CERTIFICATE OF APPROPRIATENESS PLACARD

COA-0058-2025

CoA Application for Minor Work at 903 West Lenoir Street

Radinovic & Hyde Residence
903 W Lenoir St.
Raleigh, North Carolina 27603

L-1.1

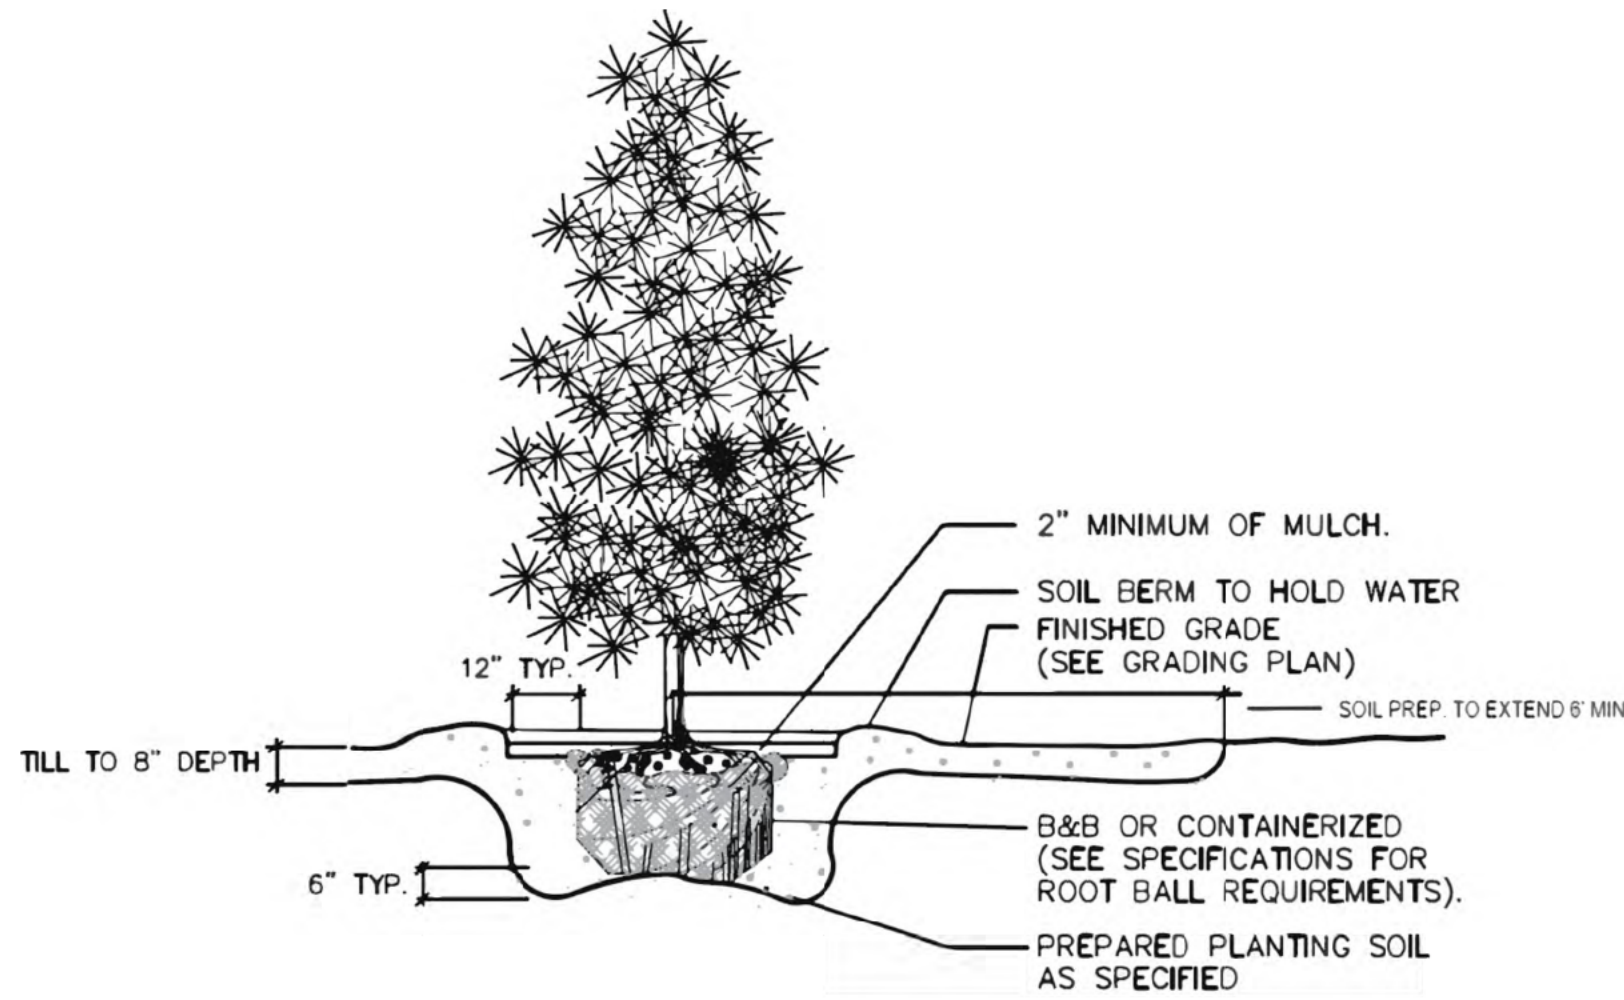
2 - Provide existing and proposed built area calculations for the property. This is similar to an impervious surface calculation but includes all improved upon areas (including gravel and other permeable pavers). **The only change to the impervious surface will be the elimination of 80ft2 of decking. This will become mulched area.**

3 – As staff, we are only able to approve fencing and screening material that is 42” or shorter. The 8’ tall trellis must be reviewed as a Major Work COA. **Understood**

4 – Will the ends of the reduced deck be kept the same as they are currently (steps down into the yard)? **Yes – no change to the existing step down design**

5 – At the end of the driveway, optional stepping stones and a wall are shown. Are those included in the project? If the wall is proposed, please include details about the dimensions, material, and design of the wall. **No work is being done on the right side of the home (viewed from Lenoir street) Our neighbor recently received approval for a major renovation on their home. The work would surely disrupt anything we have on that side of our house. It is also possible that the current plan for that side will need to change after their construction project.**

6 – Please provide additional dimensions and/or drawings for the front yard site walls. The notes indicate that it will be 12” tall – what is the wall’s depth?

7 – Please also provide product specification images for your site lighting. **We got the cost estimate for outdoor lighting – we won’t be doing any lighting!!**

Wall be built using this stone: <https://www.belgard.com/products/retaining-walls/weston-stone-wall/> Dimensions are as follows:

Two (2) custom masonry dry stack or veneer stone wall systems indicated in front yard/landscape plan.

Dimensions:

Stone wall #1 (left side of front walk):

- Approx. Length: 22 Ft

- Avg Height: 1.5 Ft (approximately 7 inches to be underground for footing)

Total SQFT: 33 SQFT

Stone wall #2 (right side):

- Approx. Length: 16 Ft

- Avg Height: 1.5 Ft (portion to be underground for footing)

Total SQFT: 22 SQFT

Cumulative SQFT: 55 SQFT
